Access Compliance Report Public Rights-of-Way (Curb Ramps)

Main Street: KEMPTON_LN Cross Street: BLAKEMORE_DR Location: S

ADA ID: RPRK211021144424 Ramp Type: Type 4 - Parallel Initial Pass/Fail: Fail Overall Compliance: No Severity Score: 2

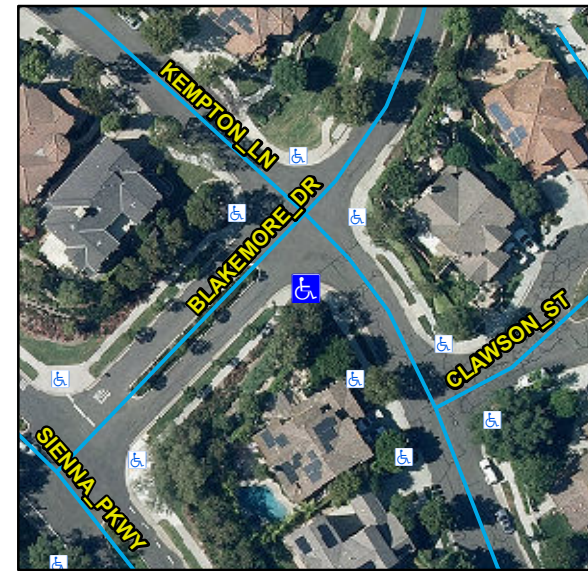
R204.3, R304.5.3, STD 1115

Compliance	Description	Data	Compliance	Description	Data
N/A	Ramp Length LT (in)	115	N/A	Ramp Length RT (in)	118
Yes	Ramp Width LT (in)	53	Yes	Ramp Width RT (in)	53
Yes	Ramp Run Slope LT (%)	8.2	Yes	Ramp Run Slope RT (%)	3.1
No	Ramp Cross Slope LT (%)	4.1	Yes	Ramp Cross Slope RT (%)	0.9
N/A	Landing Present	N/A	N/A	DWS Provided	N/A
N/A	Landing Length (in)	N/A	N/A	DWS Contrast	N/A
N/A	Landing Width (in)	N/A	N/A	DWS Length (in)	N/A
N/A	Landing Run Slope (%)	N/A	N/A	DWS Full Width	N/A
N/A	Landing Cross Slope (%)	N/A		DWS Offset Type	N/A
N/A	Landing Movement Obstructed?	N/A	N/A	DWS Offset Left (in)	N/A
	Landing Movement Type	N/A	N/A	DWS Offset Right (in)	N/A
N/A	Landing Shared	N/A			
N/A	Clear Space	Yes			
N/A	Clear Space To Crosswalk (in)	N/A			
N/A	Marked Crosswalk 1	No	N/A	Marked Crosswalk 2	No
	Crossing 1 Direction	NE		Crossing 2 Direction	NW
N/A	Marked Crosswalk 1 Width (in)	N/A		Marked Crosswalk 2 Width (in)	N/A

Remove & Replace Curb Ramp With Two New Directional Ramps or Equivalent.
